# Errata for the Compute Express Link Specification Revision 3.0

December 13, 2023

**Figure 4-57. 256B Packing: G5/H5 PBR Messages**

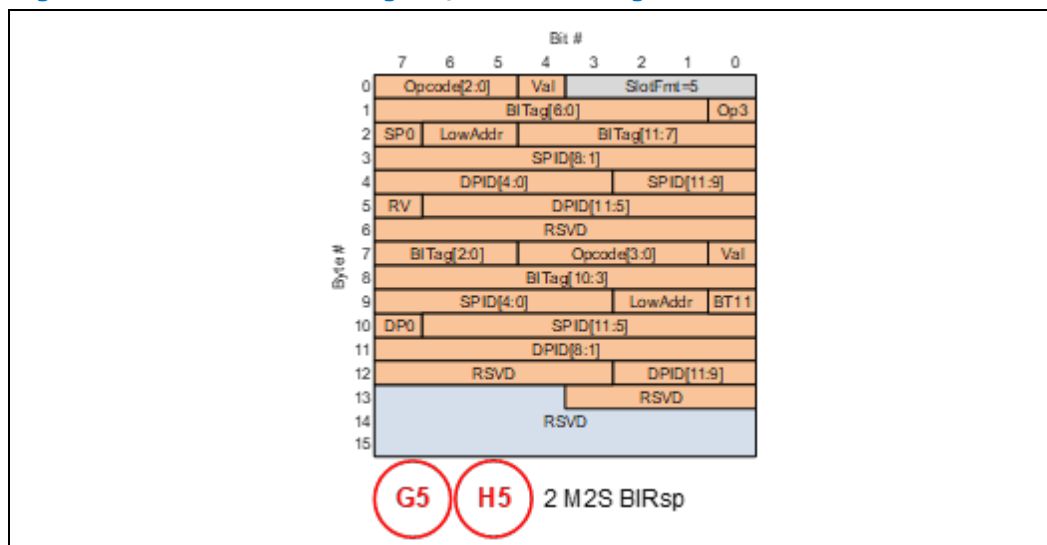
<Below are various tables and slot formats that need to need to reflect the larger PBR message size>

<Figure below replaces the CXL3 figure>

**Figure 4-70. Viral Error Message Injection Standard 256B Flit**

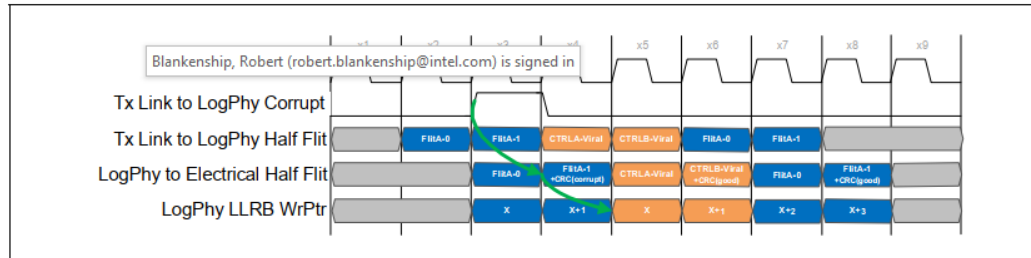
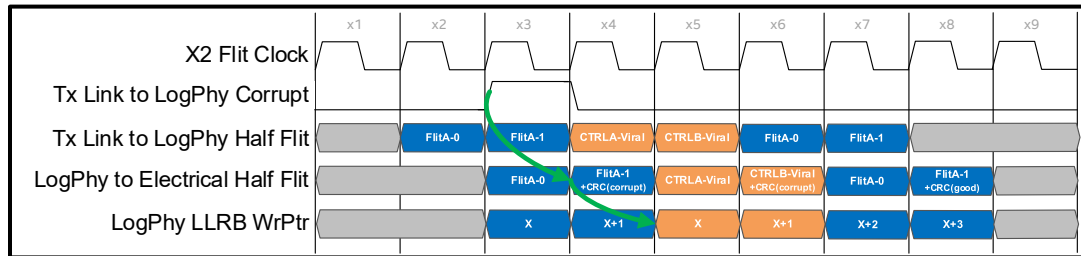
Both Figures 4-70 and Figures 4-71 should show two back-to-back flits as being corrupted. This is required to ensure that a full retry occurs at the receiver which is described in the text. The diagrams should be corrected to reflect that two flits are corrupted.

**Figure 4-70. Viral Error Message Injection Standard 256B Flit**

**Figure 4-71. Viral Error Message Injection LOpt 256B Flit**

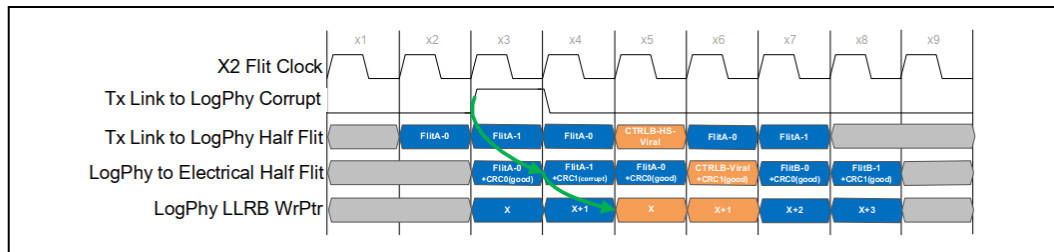
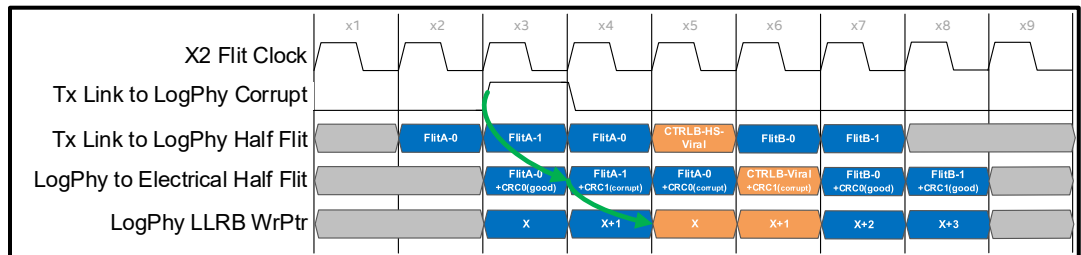
Also, Figure 4-71 is incorrectly showing "FlitA-0" and "FlitA-1" re-injected in after Viral, but it should show "FlitB\*" to match the description.

**Figure 4-71. Viral Error Message Injection LOpt 256B Flit**

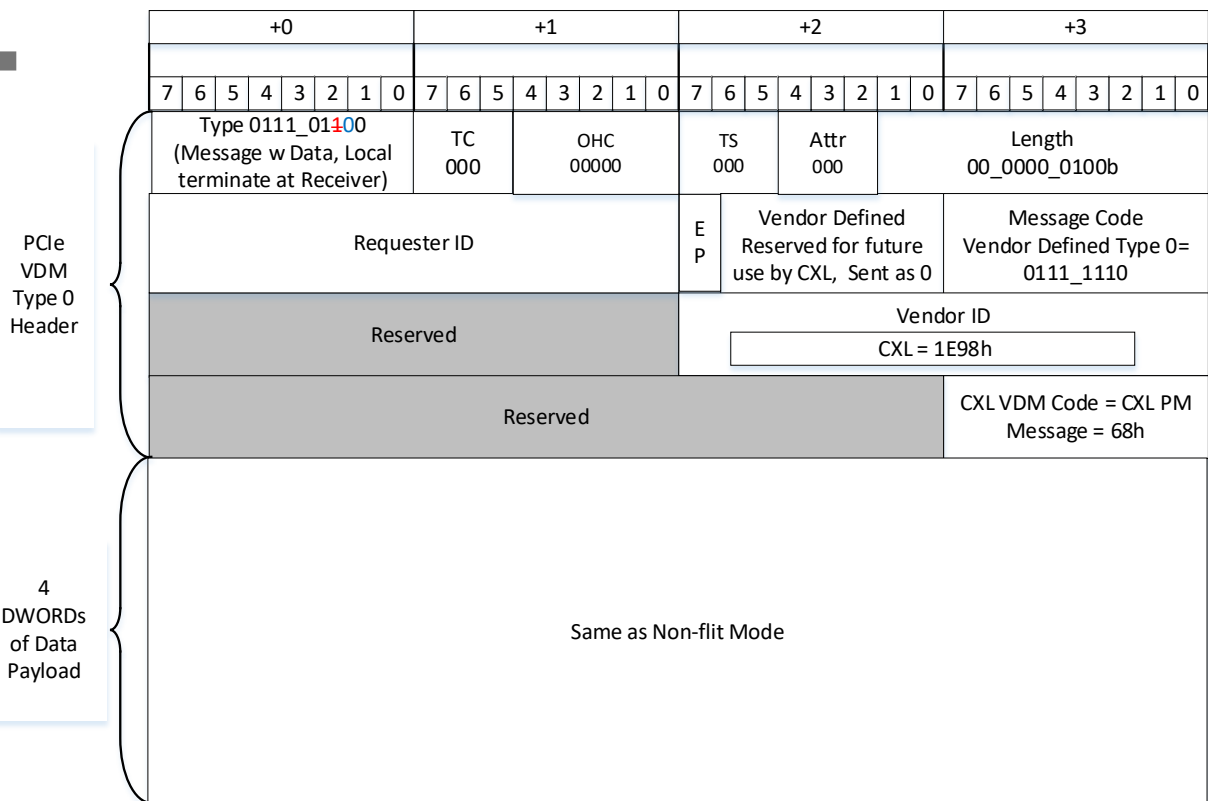
In the Implementation Note on page 630, make the following updates

3. Configure the DSP of Switch S that is directly connected to Device D to assign Cache ID=c to Device D:
  - a. Forward Cache ID=0.
  - b. Local Cache ID=c.
  - ~~c. Trust Level=0.~~
  - ~~d.~~ Assign Cache ID=1.
